# MtIntosh

C 28

## SERVICE INFORMATION

## SERVICE BULLETIN

### ELIMINATION OF TURN-ON AND TURN-OFF NOISE

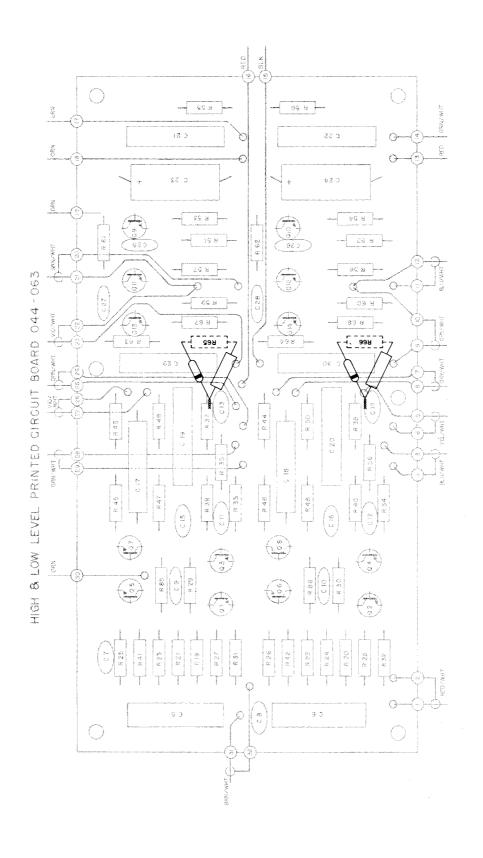
PURPOSE OF MODIFICATION: To eliminate the "shhhh" type of noise when initially turned-on, or a second or two after being turned off.

WHAT UNITS ARE AFFECTED: Serial No. 10X01 to 17X01 only.

2: Remove R65 and R66 (4.7k resistors).

Step 3: Install the new diode and resistor as shown.

#### BACKSIDE OF LOW LEVEL INPUT PLATE

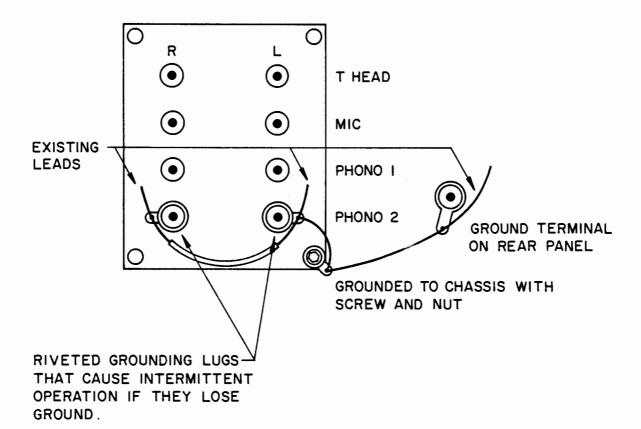
PURPOSE OF MODIFICATION: To assure that the high and low level amp. PC board 044-309 will always have a positive ground return.

WHEN MODIFICATION SHOULD BE MADE: When intermittent or complete loss of a channel is experienced in any of the low-input-level modes- or when units are being serviced for any other reason.

- 1. Remove top and bottom covers.
- 2. Unscrew screw and nut and place solder lug between plate and rear panel. Tighten screw.
- Solder bare wire between ground terminal lug on rear panel to newly mounted lug, then another piece of bare wire to rivited solder lug at Phono 2 left.
- 4. Then solder <u>sleeved</u> bare wire between phono 2 left solder lug and phono 2 Right solder lug.
- Replace top and bottom covers.

DIAG. 1

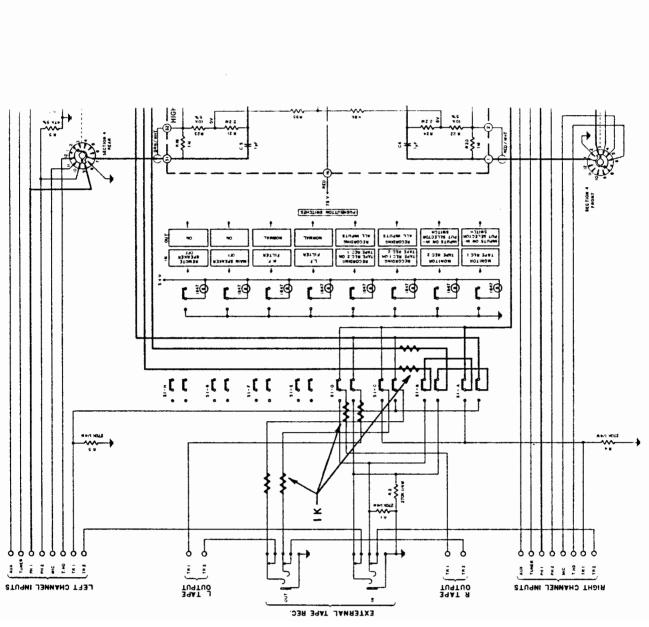
- 1. Remove top and bottom covers.
- 2. Remove the screws holding the level set panel in place.
- 3. Referring to diagram I and with the C 28 upside down, locate the four coaxial cables that connect to push button switches, SI-B and SI-D. Insert the  $IK\Omega$  resistors in series with each coaxial cable right at the switch terminal.

- 4. Referring to diagram 1 and with the C 28 upside down, replace each of the two wires (Blue and Blue/white) that connect the front panel "Tape-Output" jack with push button switch S1-B, with  $1K\Omega$  resistor. Provide sleeving on both resistor leads.

DIAG. 3

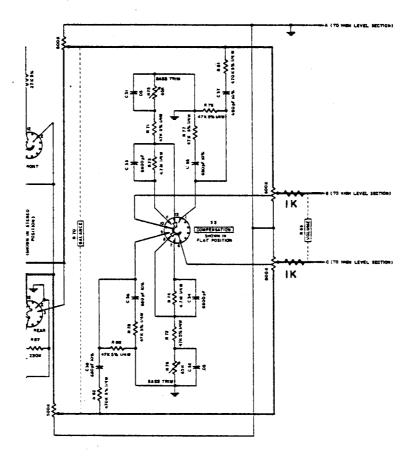
- 6. Referring to diagram 3 and with the C 28 right side up, locate the volume control underneath the level set panel. Locate the coaxial cables connected to the center lugs of the volume control. Insert a  $lk\Omega$  resistor in series with each cable right at the control lugs. Use sleeving to prevent shorting to panel.

DIAG. 4

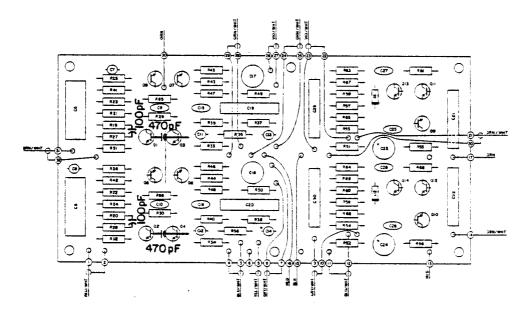
- 7. Referring to diagram 4 and 5 and with the C 28 upside down locate the 044309 high and low level PC board. Connect a 100pF and a 470pF capacitor for each channel as indicated on the PC board diagram 4 and schematic diagram 5. Capacitor leads should not exceed 1/4 inch.

DIAG. 6

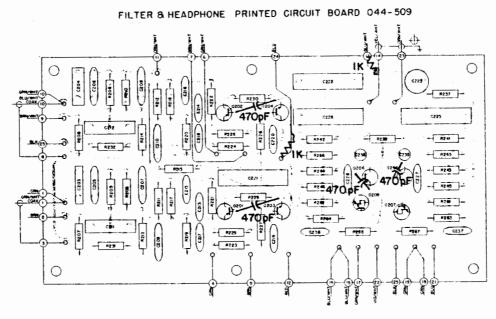
- 8. Referring to diagram 6 and with the C 28 upside down, locate the filter and headphone PC board- 044509. Insert a  $1K\Omega$  resistor in series with the blue wire connected to pin 24 and the blue/white wire connected to pin 13. Both resistors to be inserted right at the pins.

- 9. Referring to diagram 6 ans with the C 28 upside down, locate the filter and headphone PC board- 044509. Connect 2 each 470pF for each channel as indicated on the diagrams. Capacitor leads should not exceed 1/4 inch.

DIAG. 7

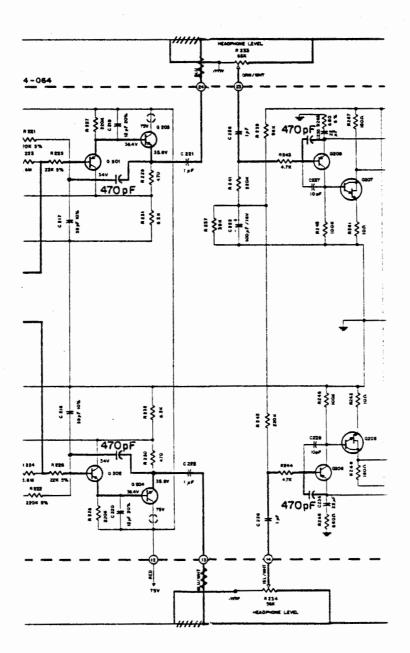
- 10. Referring to diagram 7 and with the C 28 right side up, locate the blue/white and green/white coaxial cables that connects to the right and left output level controls on the level set panel. Disconnect the blue shield wire of the blue/white coaxial cable from the terminal strip and reconnect it to an adjacent lug of the same terminal strip. This lug is already occupied by a yellow wire. Disconnect the green shield wire of the green/white coaxial cable from the terminal strip and reconnect it to an adjacent lug of the same terminal strip, already occupied by a yellow wire. The net effect of this would be as shown on diagram 7.
